**Preliminary Plat – Heimes – J & H Investments
LLC**

RECOMMENDATION REPORT

CASE NUMBER: 2016-SUB-12

RE: Preliminary Plat Application – Initial Review
Heimes

HEIMES

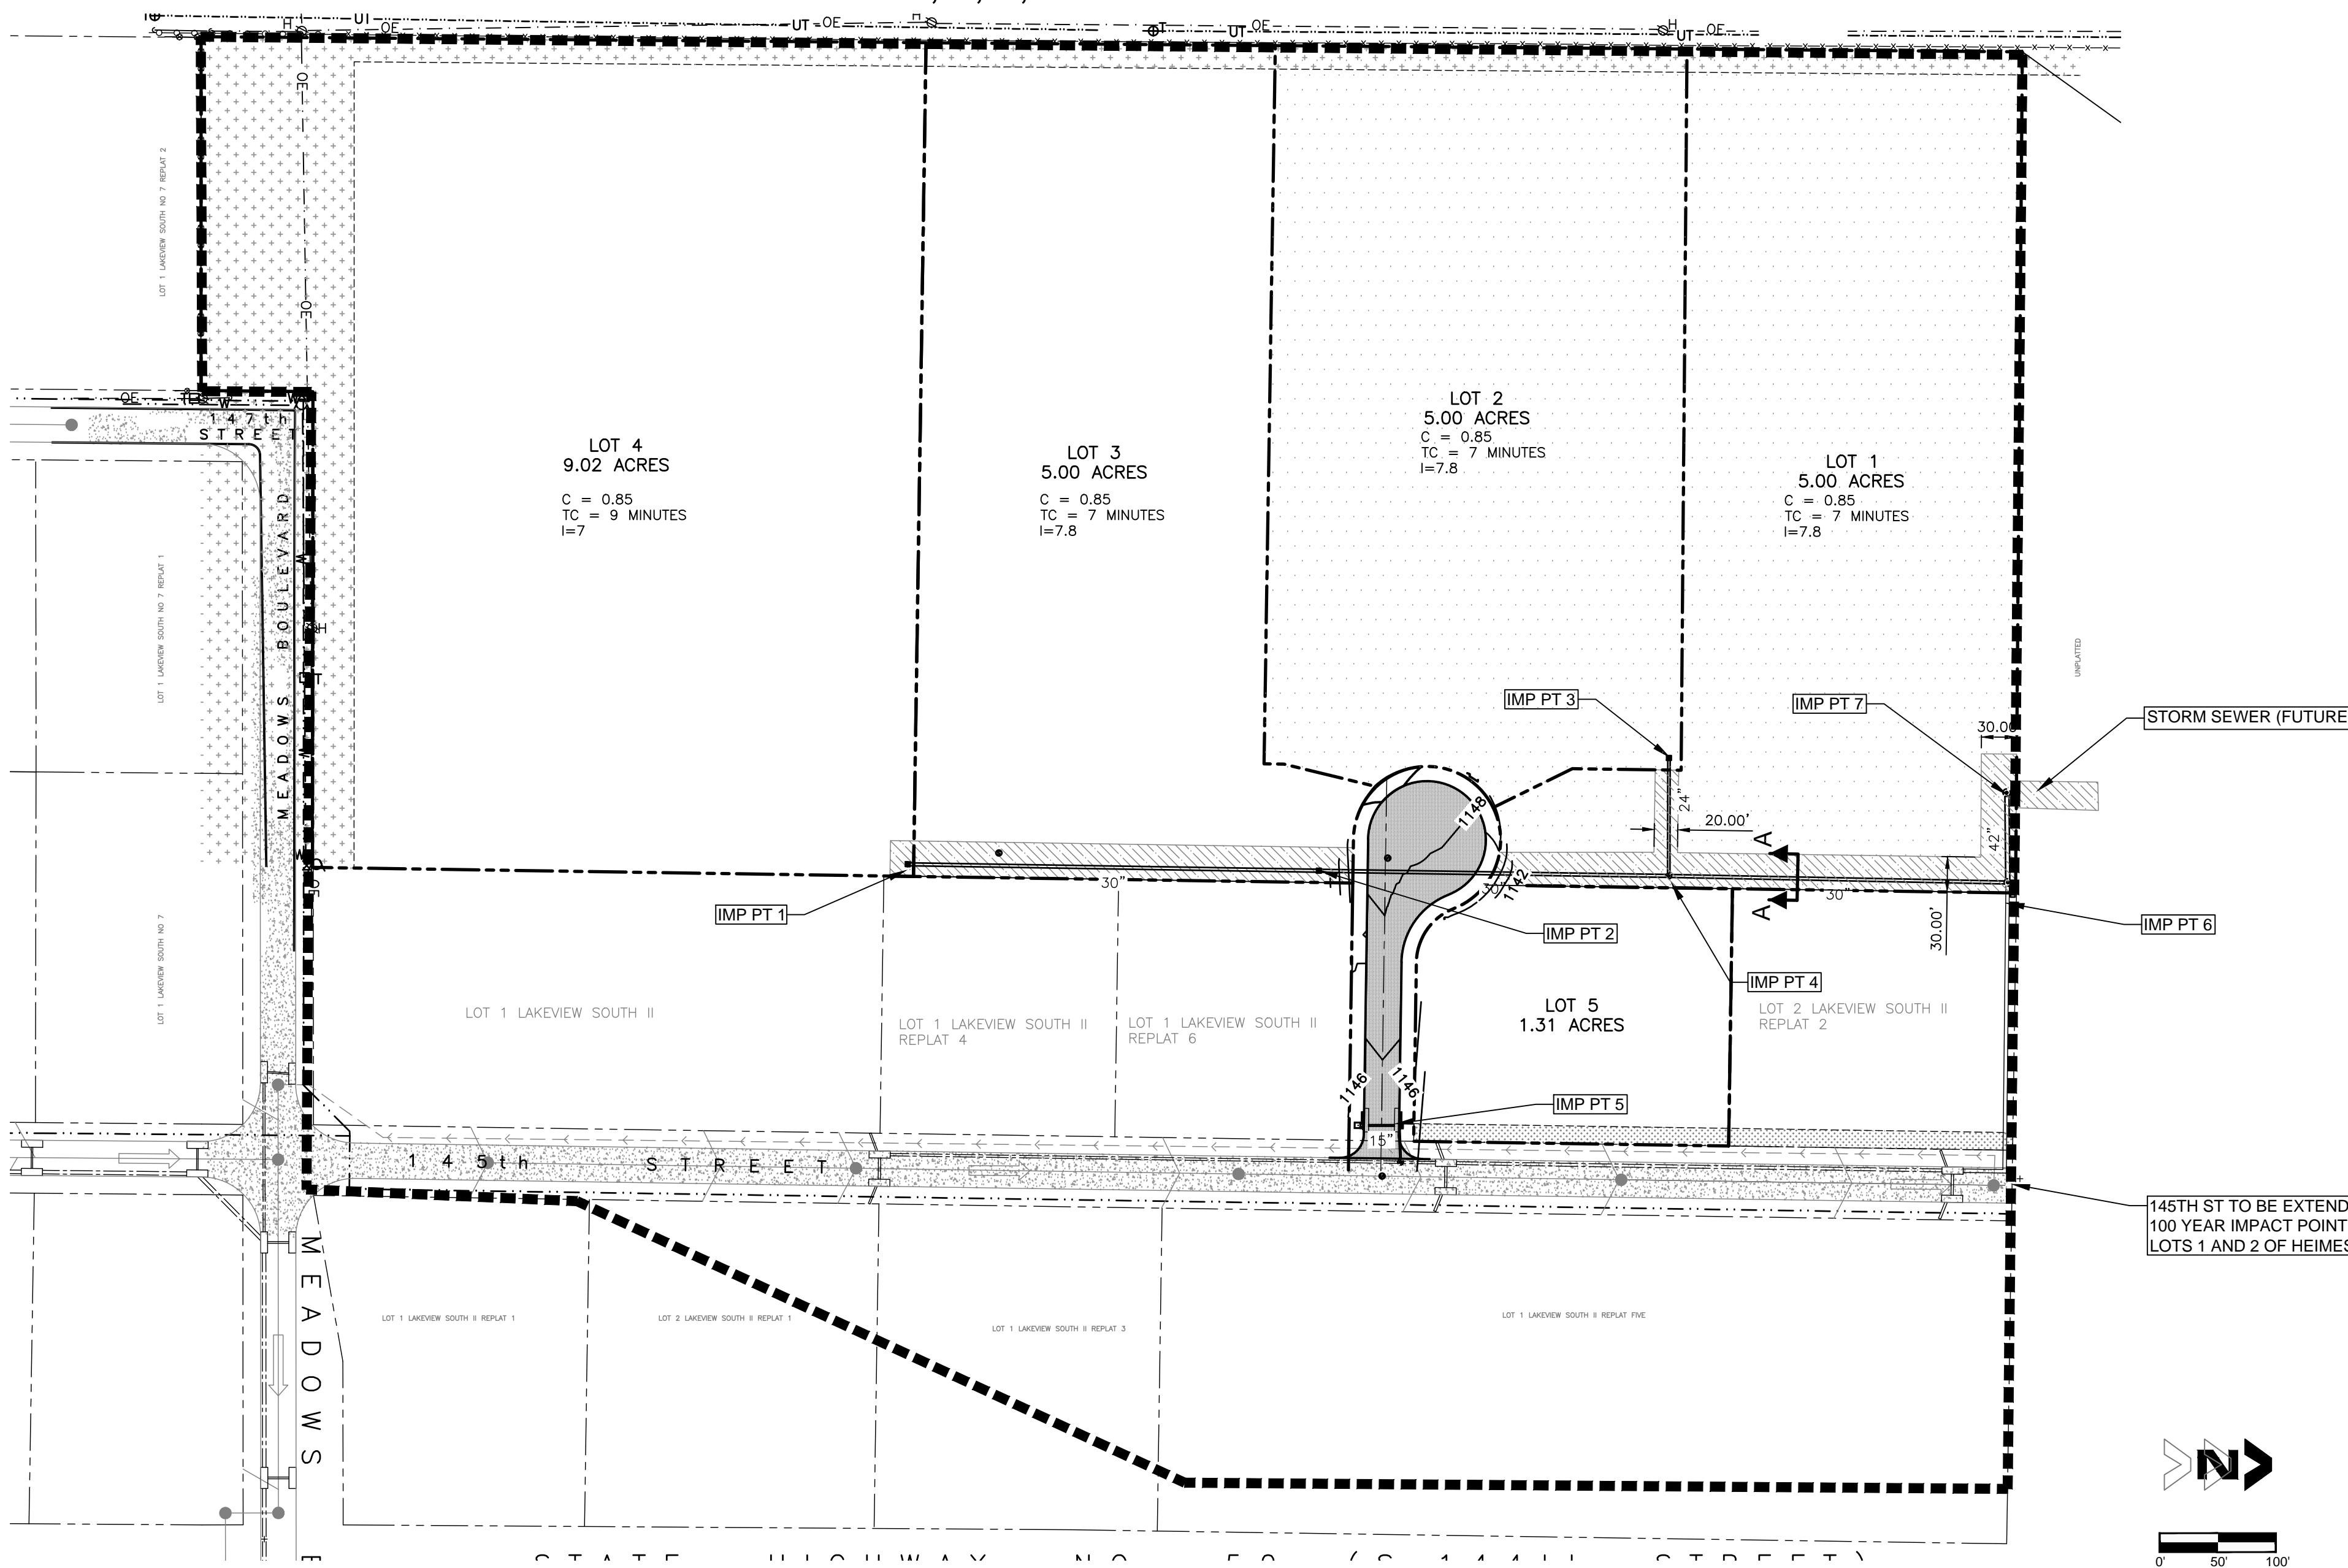
1. The graphic scale shown on the plat appears to be incorrect. It is labelled as 60 scale but it appears the drawing is 100 scale.
2. The preliminary plat should be sent to the Papio-Missouri River Natural Resources District for review and comment since it abuts the Wehrspann Lake Dam Site which is maintained by the PMRNRD.

3. Under the title on the plat there appears to be an extraneous note "Lot 1, Lakeview South II Replat Five" that needs to be removed just to avoid confusion.

4. In regards to the proposed cul-de-sac, a street name needs to be assigned by City staff, in conjunction with Sarpy County GIS and Sarpy County 911. A determination will be forwarded upon the finalization of a name. For compliance with Article 3.03.10 some additional notes concerning the proposed public street are needed to identify the thickness of the proposed pavement (9" required) and corner radii at 145th Street.

6. A proposed storm sewer and water easement is shown on the preliminary plat to the north line of proposed Lot 1. The location of the drainage easement

that continues to the north in the Woodhouse Place preliminary plat needs to be shown to illustrate coordination. There also needs to be explanation for calling this a water easement since the Woodhouse Place preliminary plat does not identify a water easement, just a storm sewer easement. The easements will need to be granted to the entity that will be responsible for operation and maintenance of the improvements. This can be resolved as part of the final plat and subdivision agreement process.

- 1) The Scale has been corrected.
- 2) The plans have been sent to Amanda Grint with the Papio NRD for review and comment.
- 3) The note has been removed.

- 4) Paving thickness has been added on the legend, and the radii have been added as well.
- 5) A note has been added that MUD water will be serving the subdivision.

- 6) The easement information has been updated.
- 7) A cost sheet has been prepared and is attached.
- 8) A note stating that each lot will be required to get its own grading permit.
